Fox Run JSP13-64

Public hearing at the request of Erickson Living for Planning Commission's recommendation to the City Council of a Revised Preliminary Site Plan with a PD-1 Option, Revised Special Land Use Permit, Revised Phasing Plan, Revised Woodland Permit and Revised Stormwater Management Plan approval. The subject property is 102.8 acres in Section 1 of the City of Novi and located north of Thirteen Mile Road and west of M-5 in the RM-1, Low Density Low-Rise Multiple-Family District. The applicant is proposing to revise the original approval and layout of the remaining buildings in Phase 2.

PLAN REVIEW CENTER REPORT

Fox Run – Revised Preliminary Site Plan
JSP13-64

FOX RUN MASTERPLAN 2013

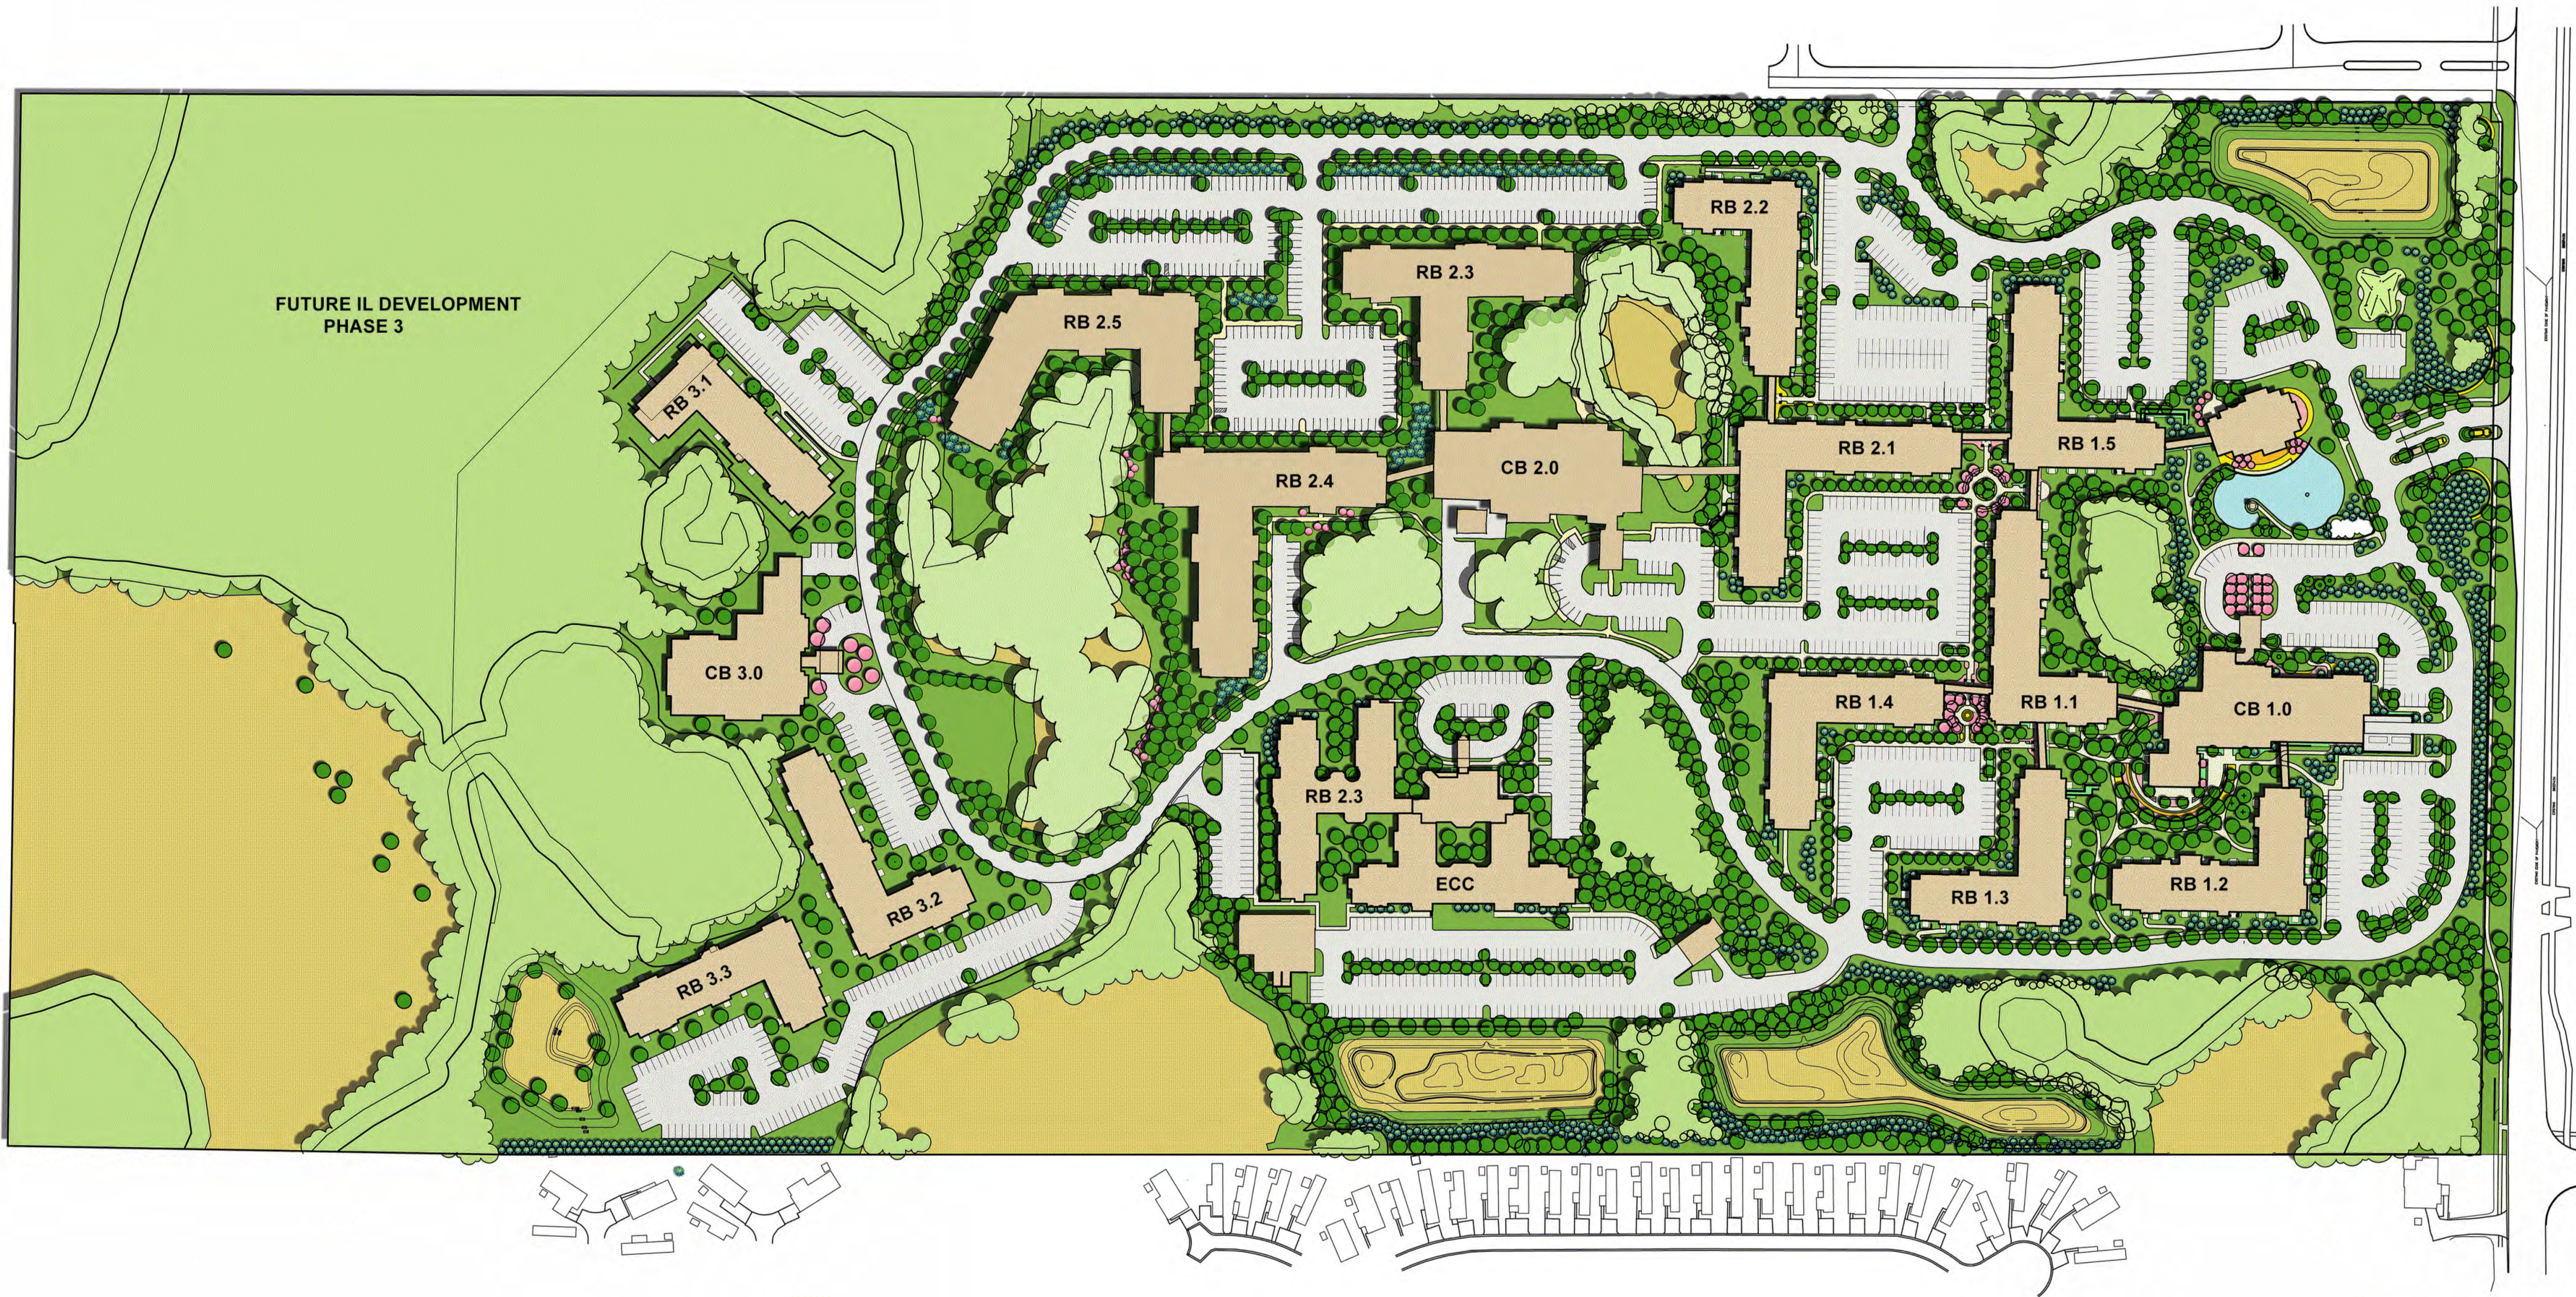
1. Photometric Plan: **There are several minor items noted in the lighting review chart that should be addressed on the Final Site Plan submittal.**
2. Signage: Exterior Signage is not regulated by the Planning Division or Planning Commission. Please contact Jeannie Niland (248.347.0438) for information regarding sign permits.
3. Outstanding Construction and Site Close-Out Issues: There are several outstanding issues related to site work and construction of the phases that have been started or completed. These issues must be addressed. The applicant should work with Sarah Marchioni (248.347.430) in the Building Division regarding these items and should provide documentation they are working toward resolution prior to the Planning Commission meeting.

- Construction of three multi-story buildings totaling in 369 units and associated parking. Site access would be provided access points off of Fox Run Rd.
- Water service would be provided by an 8-inch extension from the existing 12-inch water main Fox Run Rd. A 6-inch domestic lead and a 6-inch fire lead would be provided to serve each building, along with three additional hydrants.
- Sanitary sewer service would be provided by re-aligning the existing 8-inch sanitary sewer. A 6-inch sanitary sewer lead is provided for each building.
- Storm water would be collected by connecting to the existing storm sewer network for the development.

1. The applicant is proposing to construct several parking lots, containing a total of 280 parking spaces, to serve Buildings RB 2.4 and RB 2.5.

5. The east parking lot access drive has been appropriately dimensioned as 24 ft wide. Per the City's Design and Construction Standards and typical engineering practice, this width is from back-of-curb to back-of-curb. However, a note in the lower right corner of sheet CE 101 now reads "All dimensions are from face of curb." **This note should be reworded to indicate that "All driveway widths and curb radii are referenced to back of curb. Unless otherwise specified, dimensions of parking spaces, drive aisles, sidewalks, and other elements are to face of curb or walk."**

6. A STOP sign of unspecified size is now proposed at each parking lot egress point. **The size of the octagon containing the word STOP should be specified, and if overall Fox Run traffic signing standards call for an alternative background panel for the octagon, a facsimile of the total sign installation should be detailed on the plans.**

8. The plan now shows a total of three van-accessible parking spaces, not two as indicated in the engineer's transmittal letter. Regardless of the number of van-accessible spaces required by ADA regulations, every space adjacent to an 8-ft-wide access aisle qualifies as van accessible and should be signed as such. As now configured, **six of the twelve barrier-free spaces should be signed as van-accessible.**

9. The Barrier Free Parking Sign Detail (on sheet CE 101) must show the correct conceptual sign design and MMUTCD sign codes:
 - a. **The R7-8 must include the word ONLY below in the white space below the wheelchair.**

8. All six barrier-free parking spaces adjacent to an 8-foot wide access aisle shall be signed as "van accessible".
9. a. The R7-8 Sign shall include the word ONLY.
b. The van accessible sign shall be revised to R7-8P.
10. The sign legend shall be converted to a sign quantities table and list each sign by description, MMUTCD code, and quantity required.
